Procedure and Form Change Request

Document No.: MP 722.2

Title: Overhaul of Worthington Service Water Pumps

To increase the amount of material that can be removed from the tension bearing shoulder.

Figure – 1. Tension Bearing Contact Check Measurement

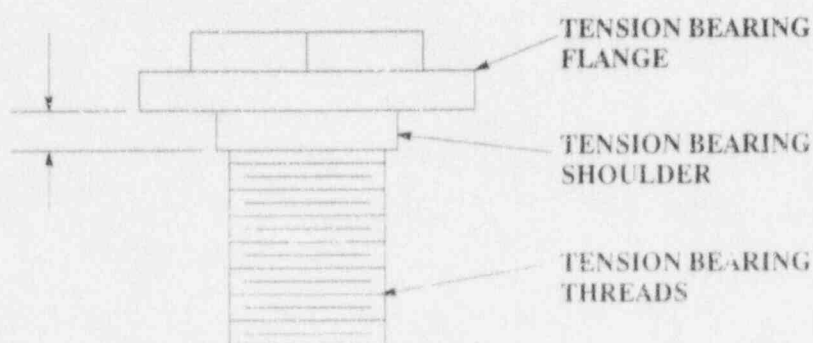
4.5.68 IF dimension between bottom of tension bearing flange and top of tension bearing threads is *greater than* dimension between top of stuffing box flange and top of shaft enclosing tube, Refer To Attachment 5, and MACHINE tension bearing shoulder *no more than* ~~0.250 inch.~~
0.500 inch.

Attachment 5 Tension Bearing Modification Detail

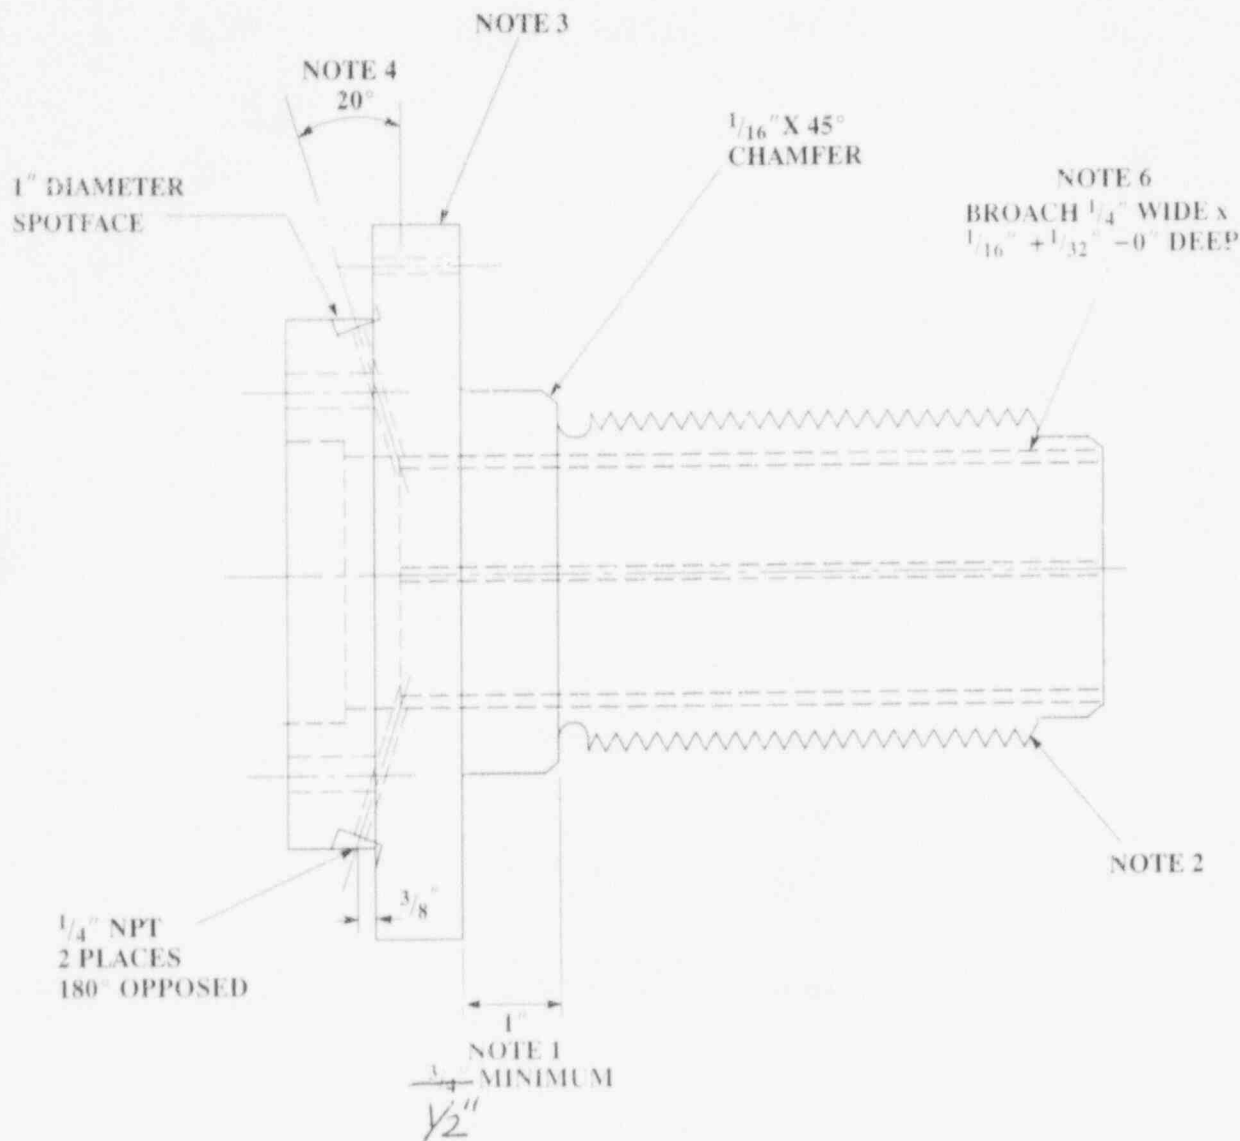
1. TRIM AS REQUIRED (1/4" MAXIMUM) TO ENSURE TENSION BEARING PRELOAD IS OBTAINED PRIOR TO BOTTOMING OUT ON TOP SHAFT ENCLOSING TUBE. (AMOUNT VARIES DEPENDING ON PUMP COLUMN LENGTHS). MACHINE CHAMFER AFTER TRIMMING.
2. TRIM THREADS AS REQUIRED (1/2" MAXIMUM) TO ENSURE TENSION BEARING PRELOAD IS OBTAINED PRIOR TO BOTTOMING OUT ON SHAFT ENCLOSING TUBE INTERNAL THREADS.
3. SKIM OD TO OBTAIN CONCENTRIC SURFACE AS REQUIRED FOR DIAL INDICATOR DURING COUPLING ALIGNMENT.
4. THESE DIMENSIONS ARE NOT CRITICAL. THE DIMENSIONS SHOWN ARE APPROXIMATIONS.
5. THIS HOLE IS FOR THE INSTALLATION OF A SETSCREW USED FOR PUMP ALIGNMENT.
6. BROACH FOUR FULL LENGTH WATERWAY KEYSLOTS 90° APART. SPECIAL BROACH IN UNIT 1 MAINTENANCE SHOP.
